SANDY SPRINGS
GEORGIA

P&Z STAFF REPORT

Board of Appeals Meeting, August 11, 2020

Case: **V20-0023 – 4900 Jett Road**
Staff Contact: Madalyn Smith (msmith@sandyspringsga.gov)
Report Date: July 21, 2020

Figure 1.

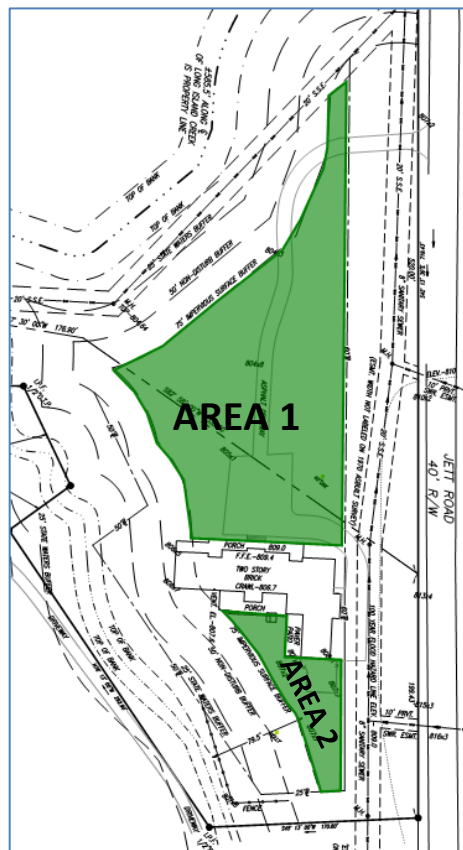
The proposed location is a logical one because it is already cleared, flat, and not located in the Future Floodway. However, Staff's view is that there is sufficient space and agreeable topography to construct a pool without encroaching into the Stream Buffer in particular, as well as the additional Impervious Setback, in Area 2 (See Fig. 1).

South and west of the home, the rear yard, is mostly encumbered by stream buffers. The buildable area is labelled in Figure 1 as Area 2. However, it should be noted that a pool in this location would result in the loss of tree canopy.

Figure 2. Future Floodway shown in red
Future Floodplain shown in blue

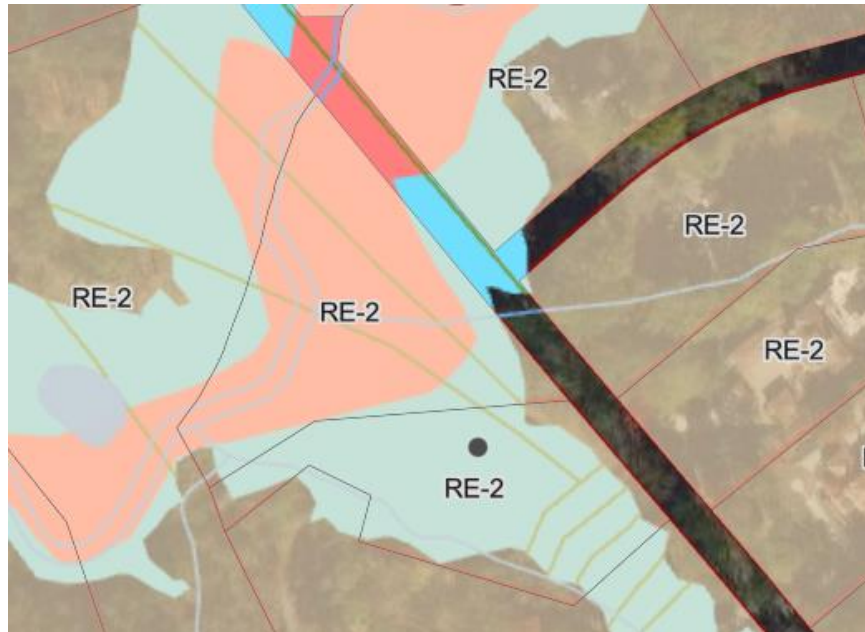
Findings: The property meets the minimum lot width and lot area requirements for the zoning district RE-2. The property is mostly flat, with a very gentle slope, approximately 20 feet over the course of the entire property. The house itself is uniquely oriented: the front of the house faces north (technically the side yard), away from Jett Road so the area that would typically serve as the side yard is practically the front yard, see Figure 1. The side yard ("front yard") is labelled as Area 1, the rear yard as Area 2. Area 1 is located in the Future Floodway, where no new construction can be done (see Fig. 2). Much of the remainder of the property is located in the Future Floodplain (see Fig. 2).

Figure 3.

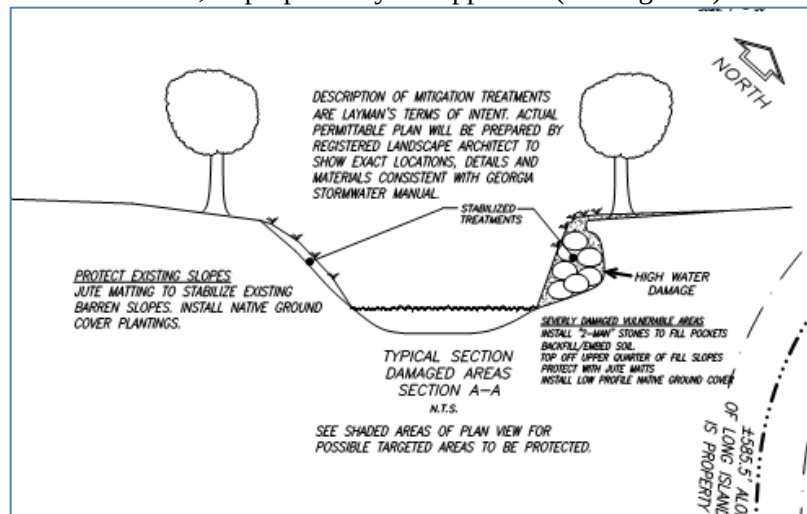
Finding: This property was developed prior to the tightening of restrictions on development near streams. The existing house is located in the buffer and much of the buffer area has been cleared and graded. The negative impacts of further encroachment in the stream buffers can be effectively mitigated through stream bank stabilization, as proposed by the applicant (See Figure 3).

Survey of 360 Lafayette, 3300 SF is buildable area outlined in blue

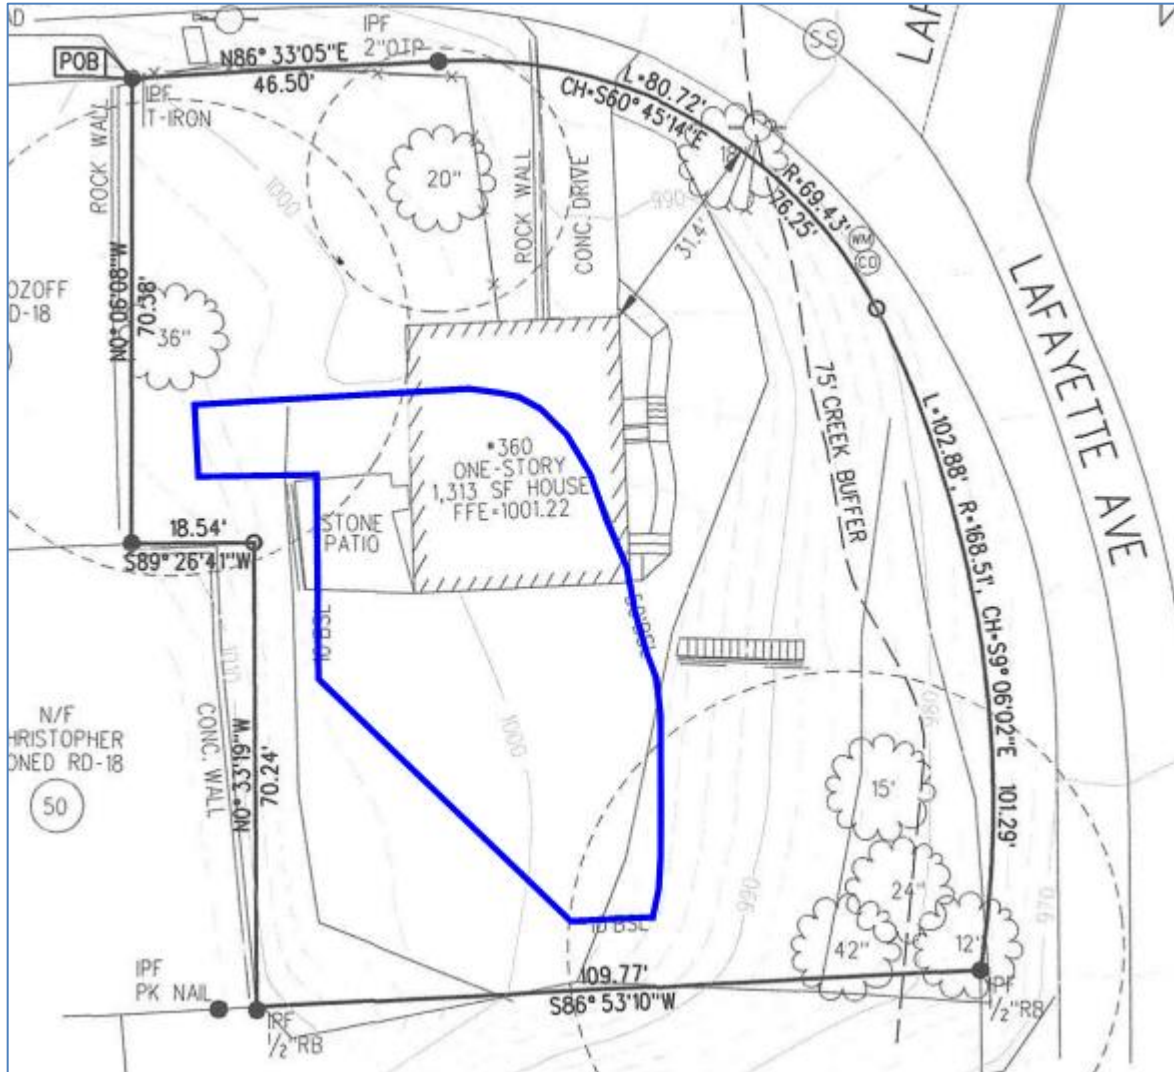
3300 SF would not be an egregiously small buildable area on a more standard shaped lot, but the pie slice shape creates a diagonal rear setback and curvilinear front setback, making much of the buildable area awkward to use and some of it not practical to use like in the northwest corner of the lot (see visual below).

SITE PLAN

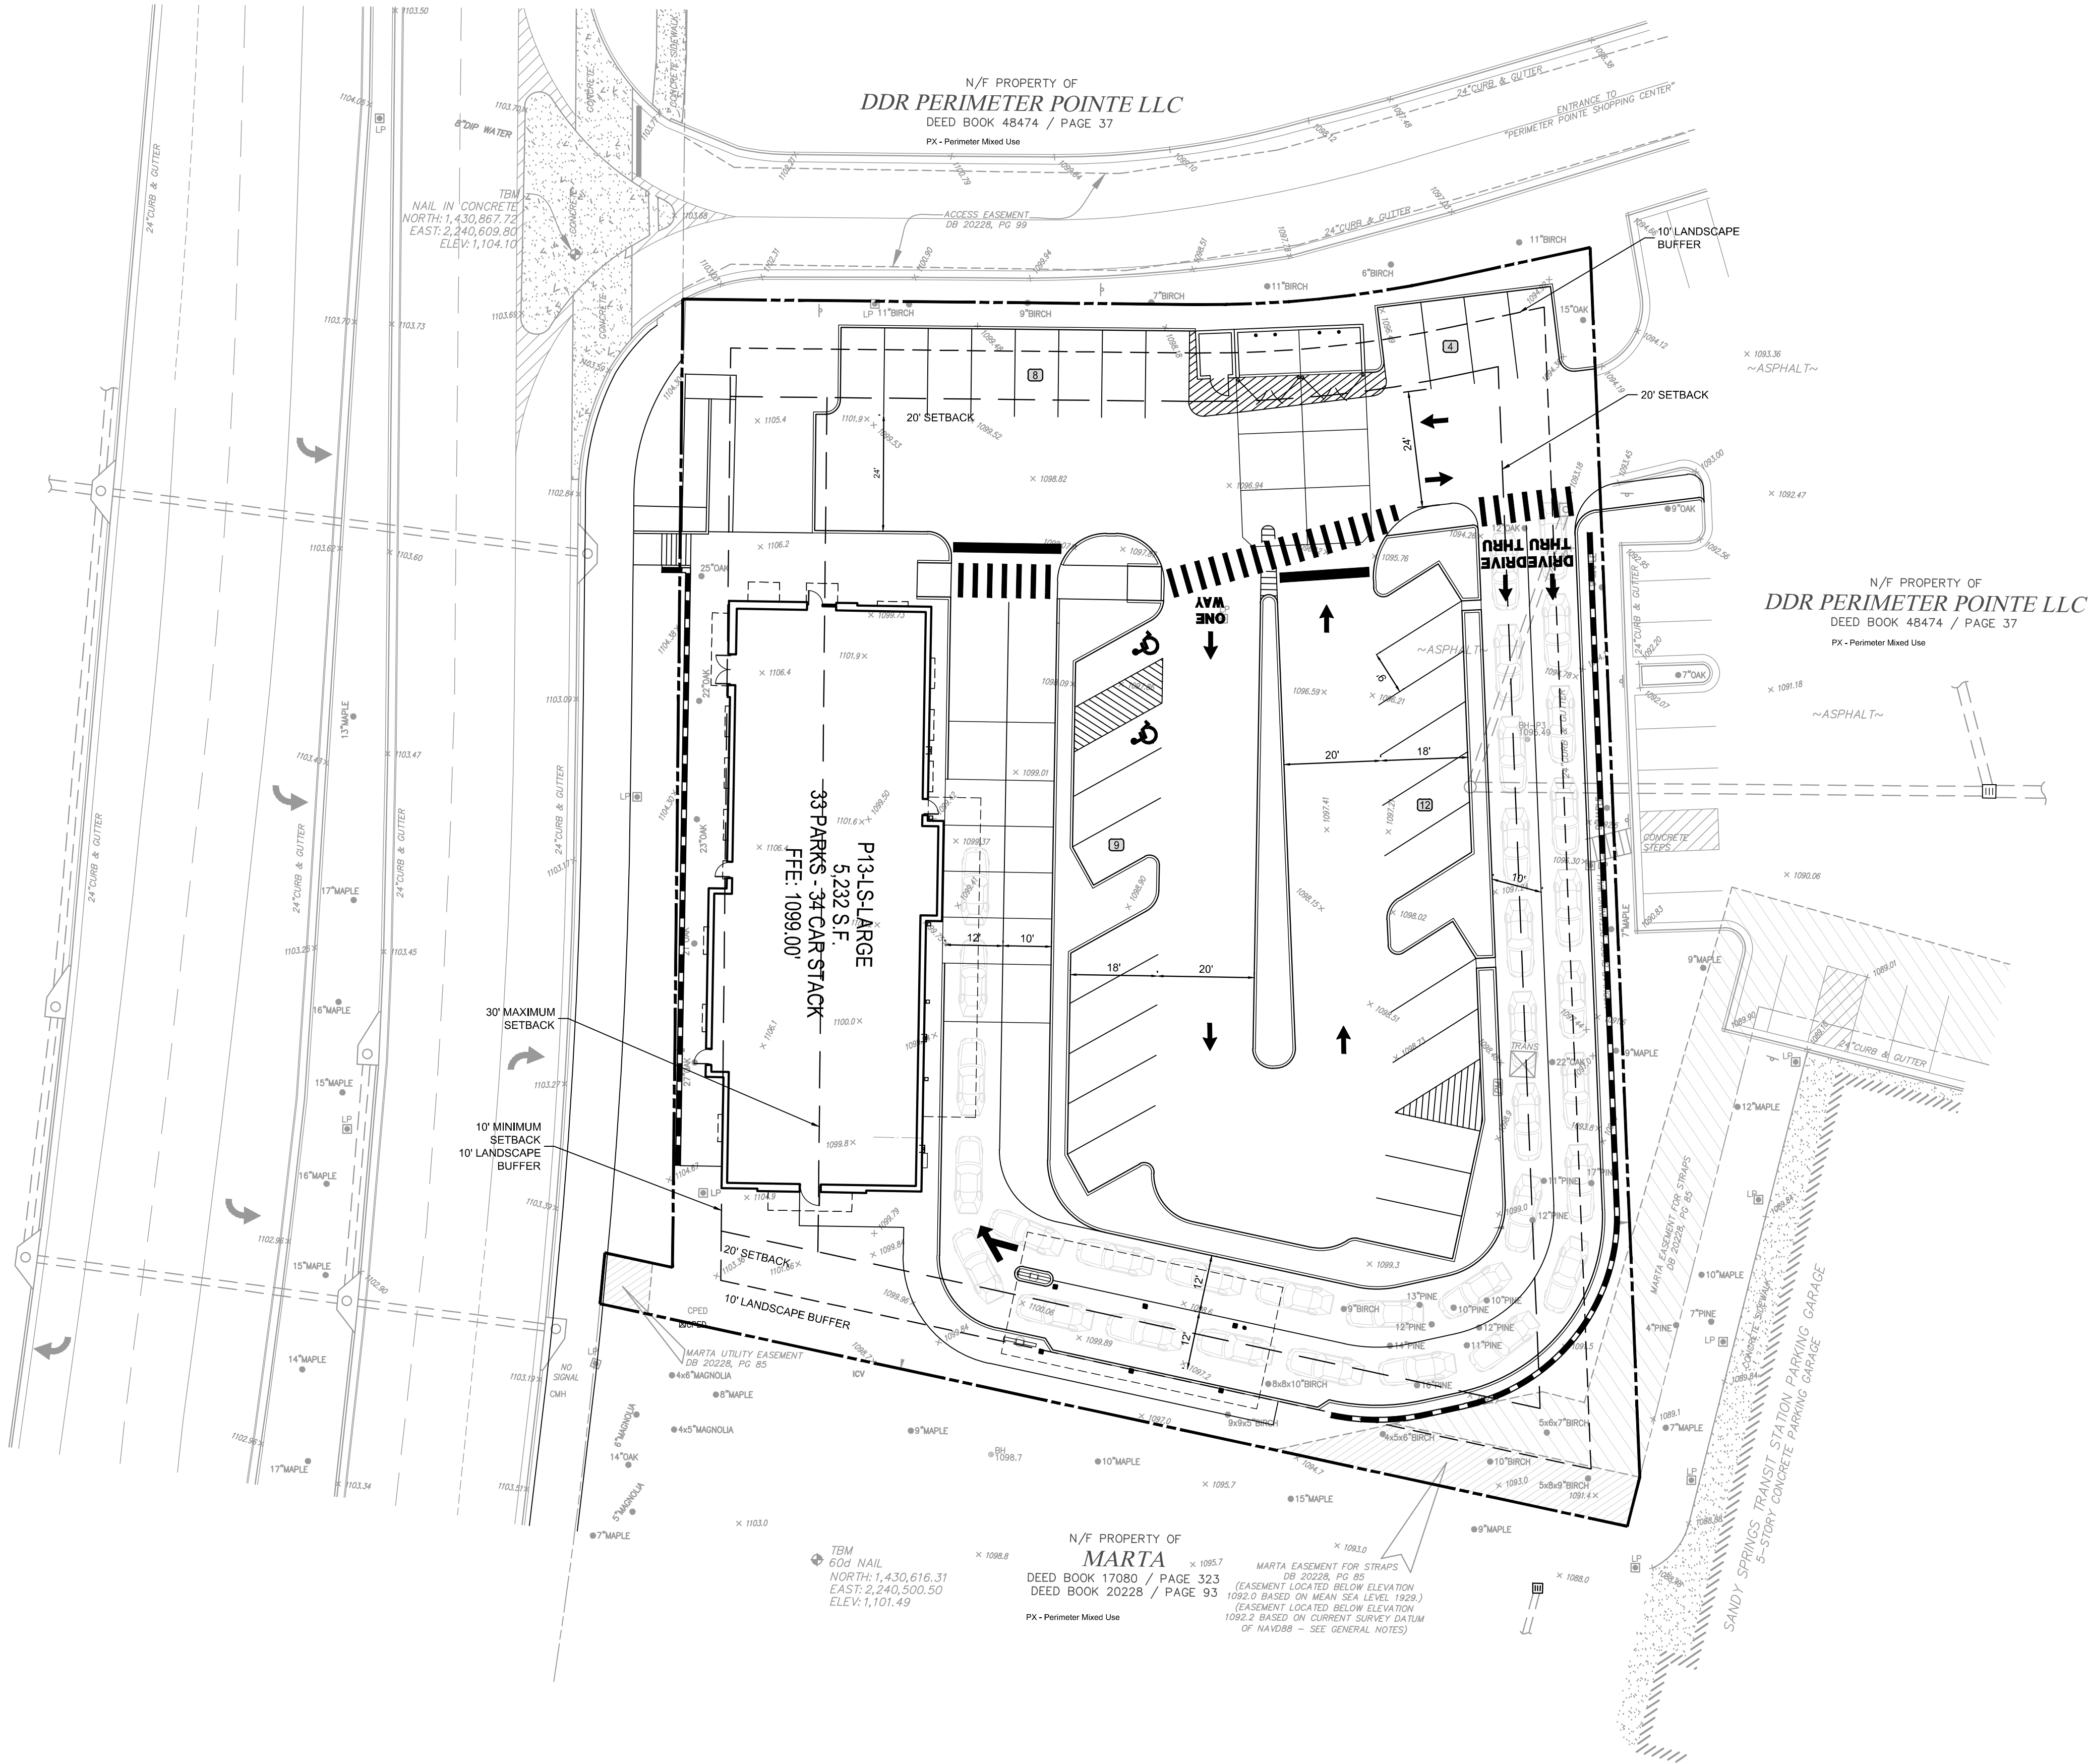
[The applicant] should be able to raise the finished floor level of the new building from the 1100.00 they show on the grading plan (which I assume is correct, rather than the 1099.00 they show on the site plan) to 1101.29 or a little higher and avoid the variance altogether.

The FFE elevation change would mean increasing the grade on the entry drive to 5% or slightly more for its entire run and would also require relocating the accessible parking to be adjacent to the north side of the building. It will also mean regrading the parking bays some.

While the rationale for this variance is accessibility, this plan does not provide for an accessible route from either the MARTA entrance or the accessible parking they show, so the accessible parking needs to be relocated, anyway. An accessible route to the MARTA entrance would be desirable but, in this situation, appears impractical, since it would likely need to cross both MARTA and the shopping center properties. It might be possible if they significantly alter their site to work it out but it would still very likely require an easement on MARTA property.

As I say, these changes will obviate the need for the variance and improve ADA access to the Mount Vernon sidewalk, which Jon and I agree is the more important (and practical) of the two they base the variance rationale on. It will also provide the missing access from their own accessible parking while maintaining the parking count they indicate.
